Office Action Summary	Application No. 10/552,593	Applicant(s) MOMMA ET AL.	
	Examiner GERARD T. HIGGINS	Art Unit 1785

DETAILED ACTION

6. Claims 1-3, 6, 9, 11, 12, and 20-24 are rejected under 35 U.S.C. 102(b) as being anticipated by Dang (6,471,721).

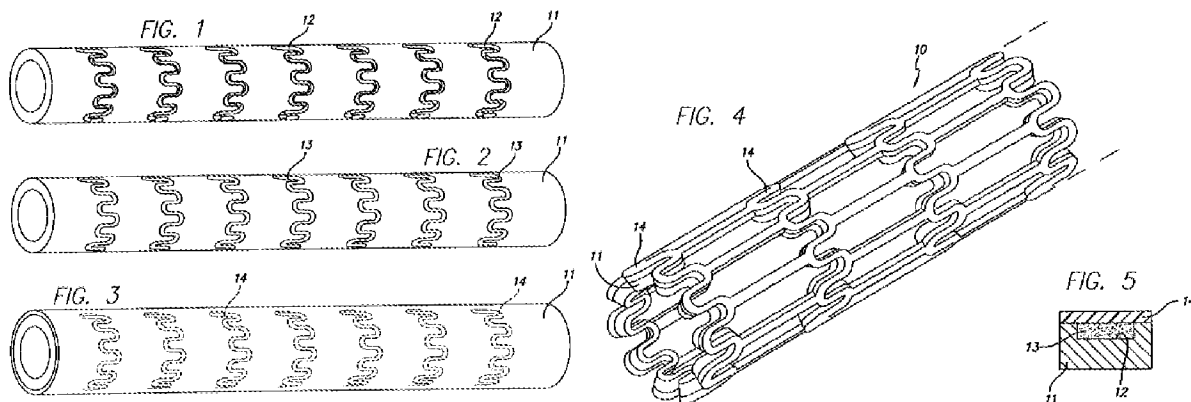
With regard to claim 2, Dang discloses the device of Figures 1-5.

The stent **10**, which reads on applicants' product-by-process limitations of a “carrier structure comprising a cut out metal tube including legs defining a mesh, and having at least one marker element welded to at least one leg”, comprises a radiolucent material, i.e. “difficult to visualize fluoroscopically” (col. 3, lines 22-31 and col. 5, lines 12-23).

The stent is produced from a cut out metal tube stock **11** (see Figure 1). The device may have radiopaque material **13**, which reads on applicants' comparatively radiopaque material, incorporated therein (col. 5, lines 38-41). Please note from Figures 1-3 that the radiopaque material is incorporated in cylindrical cut grooves **12** around the circumference of the tube stock (Figure 1-3). The cylindrically cut grooves are then

covered over with the sputtered coating **14**. The tube stock **11**, with the cylindrically cut grooves **12**, filled with radiopaque material **13**, and then covered over with the sputtered coating **14** read on applicants' at least one marker element or core filled wire. The marker elements are attached to the rest of the stent **10** (Figure 4). The radiopaque material **13** is completely enclosed by the tube stock **11** and the sputtered coating **14**, which together (**14** and **11**) read on applicants' cover layer. The material for the tube stock and the sputtered coating include metals and metal alloys (col. 5, lines 14-20 and col. 6, lines 9-11).

Although formed by a different process, i.e. forming grooves **12**, filling with radiopaque material **13** and covering over with the sputtered coating **14**, the cover layer (**14** and **11**) has the same resultant structure as a hollow wire into which the radiopaque material fills the core thereof as claimed.

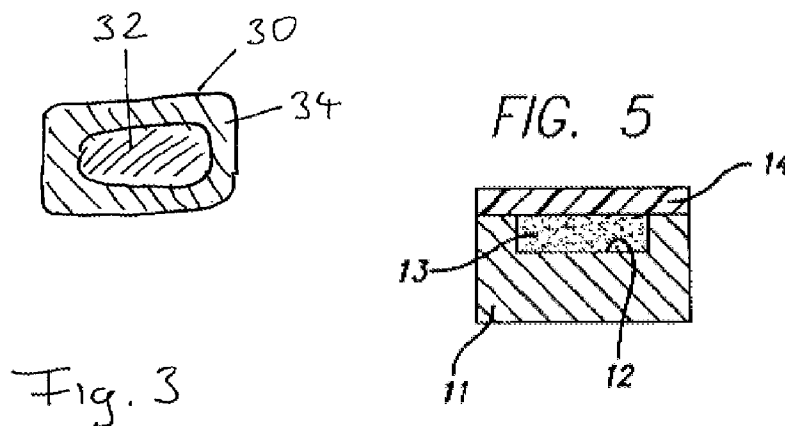
Applicants argue on page 9 of their Remarks that one of ordinary skill would not confuse the structure of Figure 5 of Dang with a core filled wire as claimed.

Again the Examiner notes that the comparatively radiopaque material "filling" a cover layer to form a "core filled wire" is a product-by-process limitation. The Examiner again respectfully disagrees with applicants' arguments and notes that the ultimate structure of Figure 3 of the current invention and Figure 5 of Dang are not different. Applicants' attention is drawn to their Figure 3 and Figure 5 of Dang.

Although the tube stock **11** and the sputtered coating **14** are shown to be distinct materials in Figure 5 of Dang, when the coating **14** of Dang is sputtered it will form a *single* material with the tube stock **11** as the two elements are comprised of the *same* material. This means that the tube stock **11** and the sputtered coating **14** will have the *same* ultimate structure as the carrier material **34** of applicants' Figure 3. This means that Figure 5 of Dang will have the *same* resultant structure as applicants' "core filled
